CALIFORNIA COASTAL COMMISSION

W 8a**STAFF REPORT AND RECOMMENDATION****ON CONSISTENCY DETERMINATION**Consistency Determination No. **CD-059-03**

FEDERAL AGENCY: U.S. Air Force**PROJECT**
LOCATION:Vandenberg Air Force Base, Santa Barbara County
(Exhibits 1-3)**PROJECT**
DESCRIPTION:Ground-Based Midcourse Defense (GMD) Initial
Defensive Operations Capability (IDOC) program
(Exhibits 2-4).**EXECUTIVE SUMMARY**

EXHIBIT NO. 3
APPLICATION NO.
CD-59-03

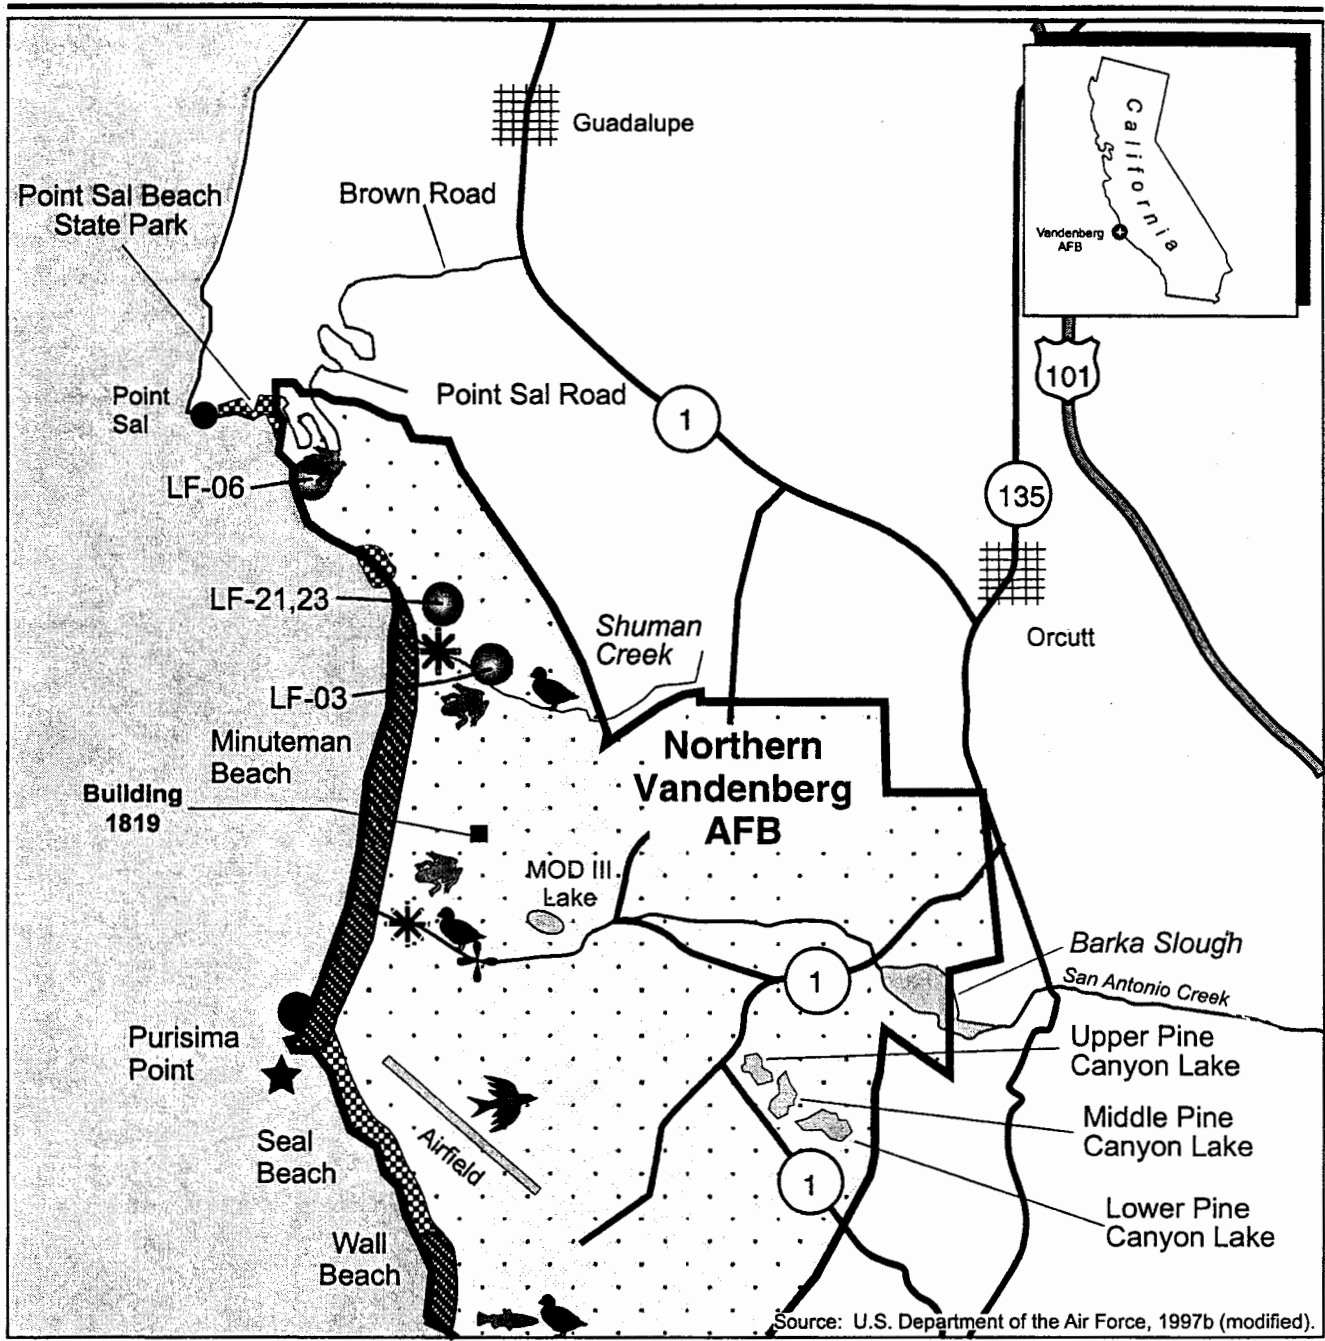
The areas affected by the proposed improvements would be limited to existing developed areas, primarily on northern Vandenberg AFB, and would be located away from environmentally sensitive areas. These sensitive areas, as well as three of the launch sites, are shown on Exhibit 3 (the other three launch sites are adjacent - see Exhibit 2).
